Town of Fort Myers Beach

Project Name: MATANZAS INN & RESORT CPD AMENDMENT
Authorized Applicant: MURPHY PLANNING
LeePA STRAP Number(s): 19-46-24-W4-0150E.0210, 24-46-23-W3-00202.0130, 24-46-23-W3-00202.0150

MASTER CONCEPT PLAN
 MATANZAS INN
 REDEVELOPMENT

Re: DCI2013-0002 Matanzas Inn CPD Amendment

- LEGEND:**
- = OPEN SPACE
 - R.O.W. = RIGHT OF WAY
 - ① = DEVIATION
 - PL = PROPERTY LINE
 - SW = SEAWALL (WATER-SIDE EDGE)

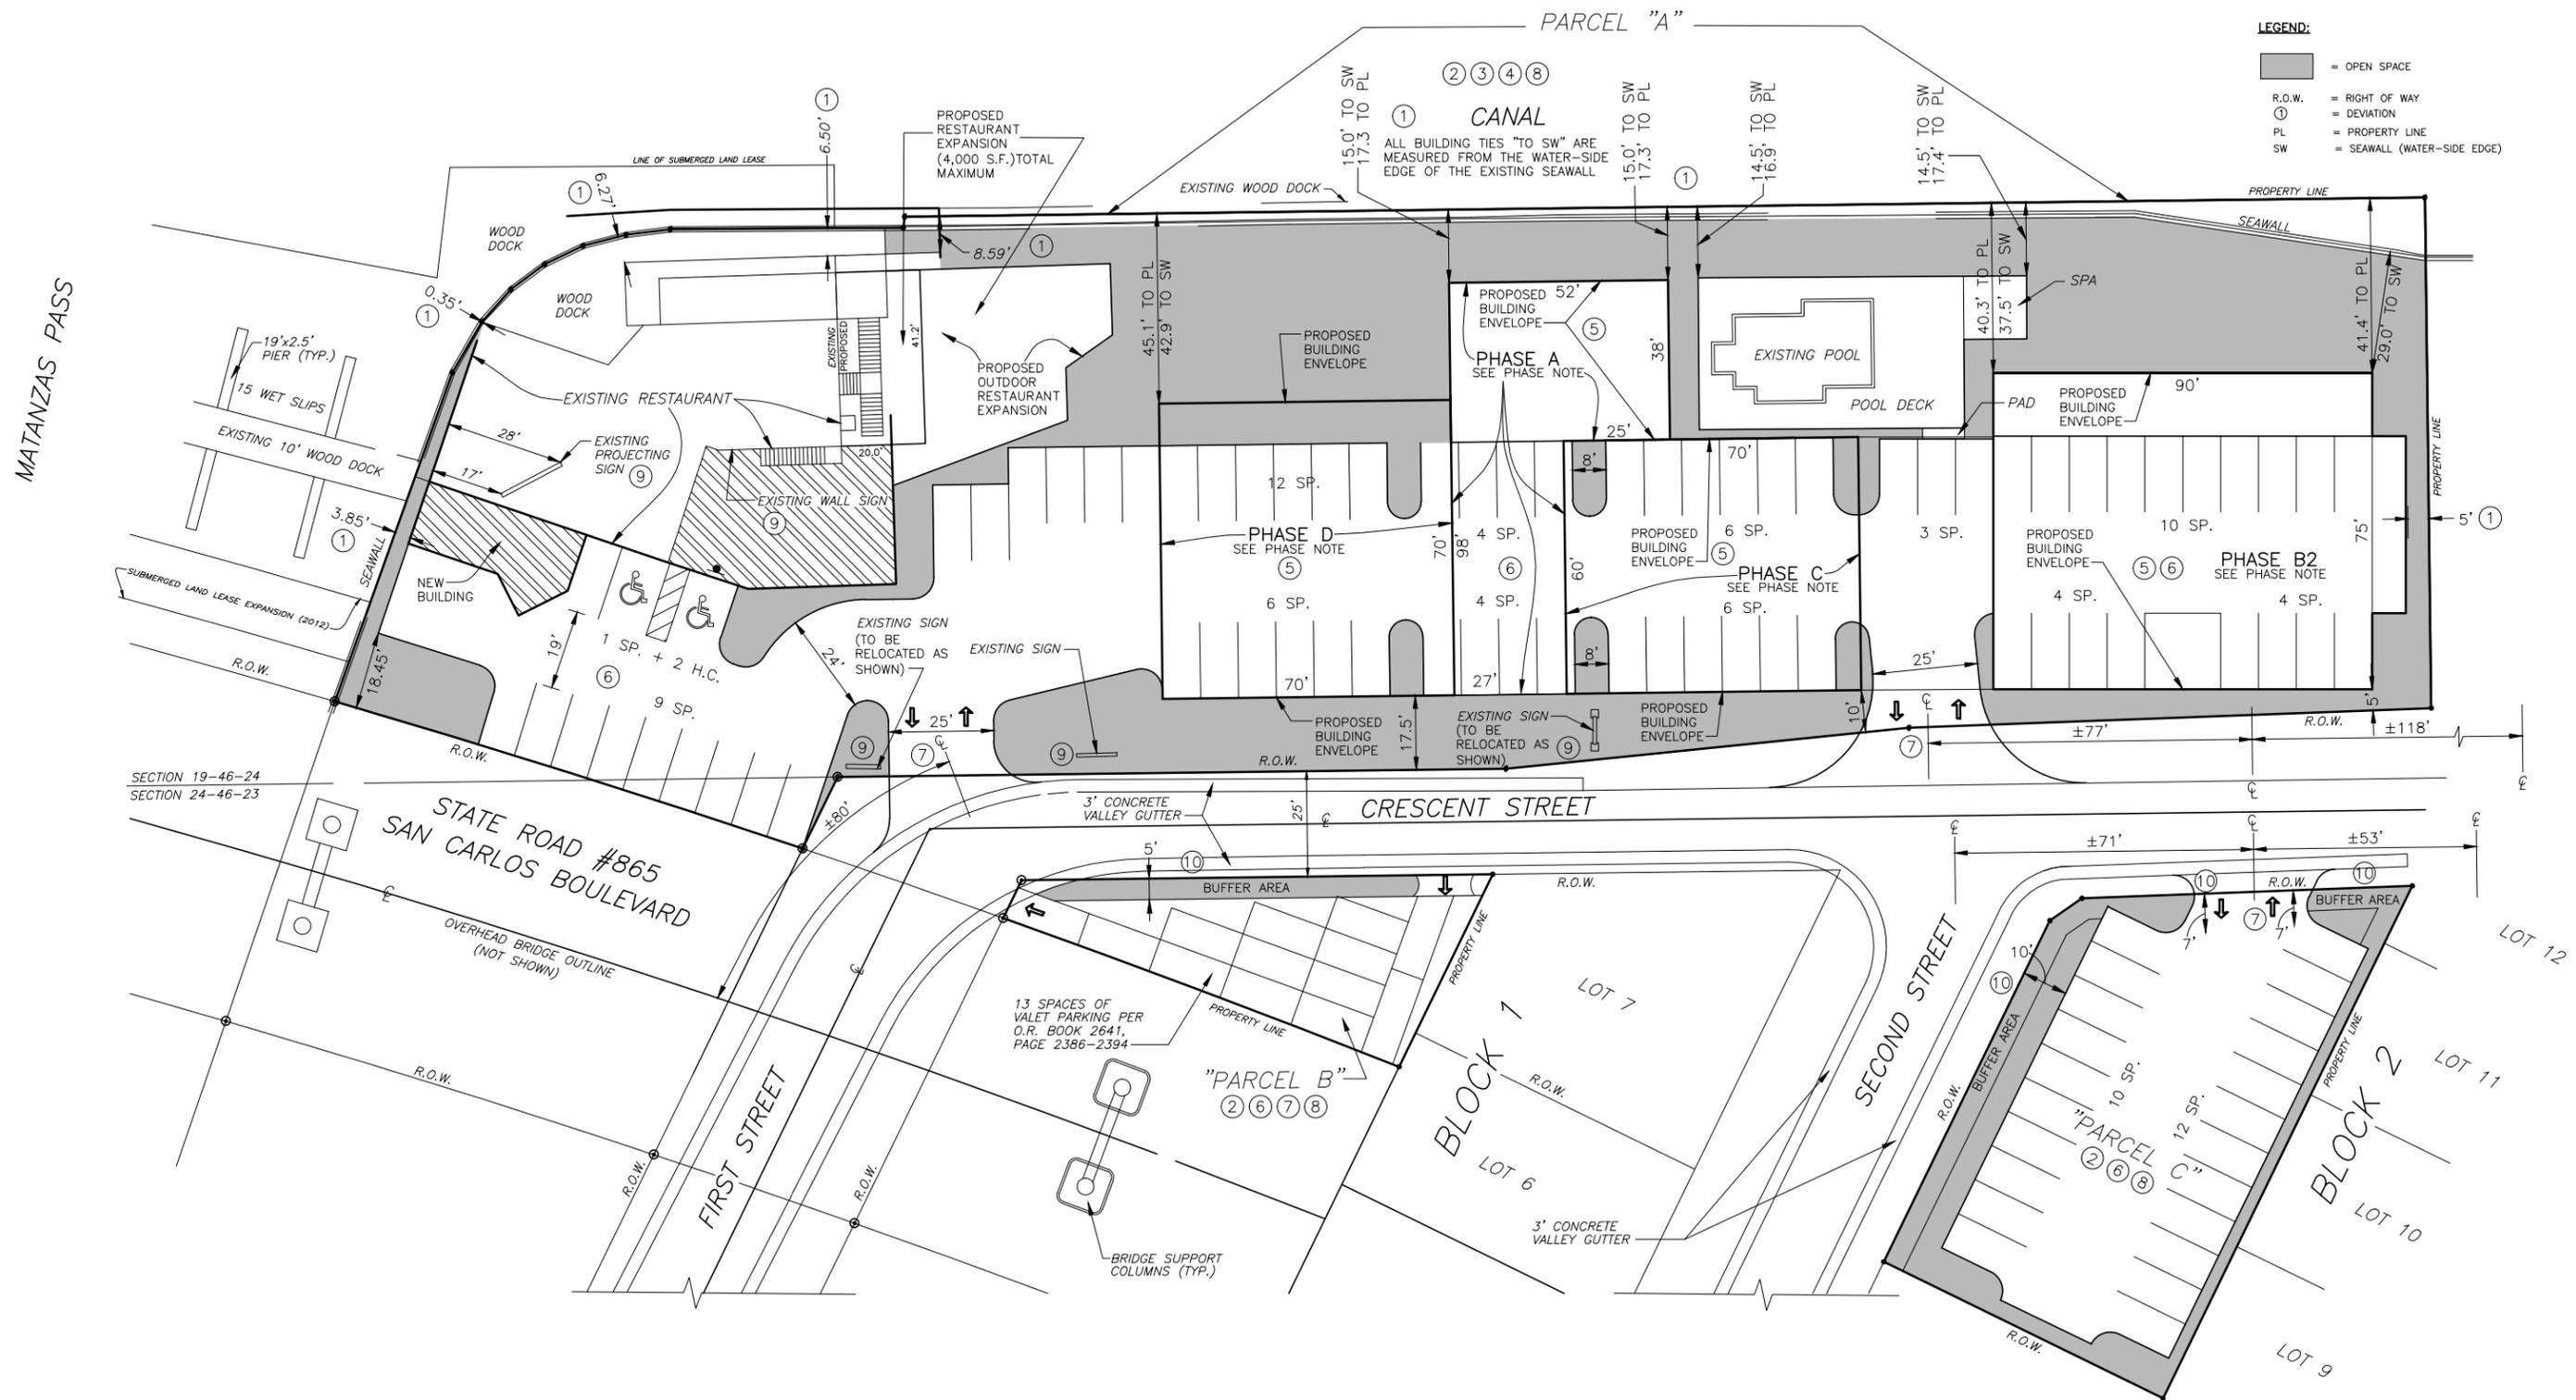
Please include a Phasing Plan, either on the Master Concept Plan or a separate drawing, identifying and indicating the scope of each Phase.

Please label and indicated areas for required buffers or provide a landscape betterment plan indicating compliance with required landscaping and buffers.

Response: Murphy Planning has revised the Master Concept Plan to identify and label phases A through D. Phase B is divided into two sub-phases: Phase B-1 proposes to develop a second floor on to the existing one-story resort motel building along the eastern half of that building facing the canal, totaling 2,200 square feet of additional enclosed building area. This phase is delineated on Master Concept Plan sheet 1 of 2. Phase B-2 proposes to raze the existing one-story resort motel building and replace it with a new two story building.

Response: The MCP has been revised as requested.

Response: The MCP has been revised to identify the phases, and the scope of each phase is indicated in the table provided in response to the request under “Supplement PH-D, B, above.

Response: The MCP has been revised to indicate areas for buffers, landscape betterment, and open space.

Response: The MCP has each building footprint identifies as a phase. Building heights will not exceed 30 feet above base flood elevation and three (3) stories.
